PRODUCT CHANGE NOTICE (QR18)

Notification Date: 20th April 2016	PCN #	MJ3205-66 B PCN
		20160420

MJ3205-66-X-X-X

Description of Changes

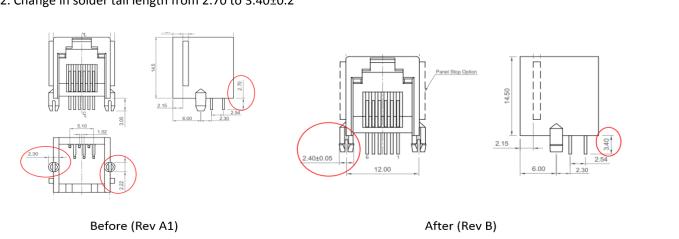
- 1. Change in peg dimension from 2.30x2.22 to 2.40±0.05
- 2. Change in solder tail length from 2.70 to 3.40±0.2

Minor dimensional changes on the peg & solder tail, no impact on footprint/PCB layout or reduced function
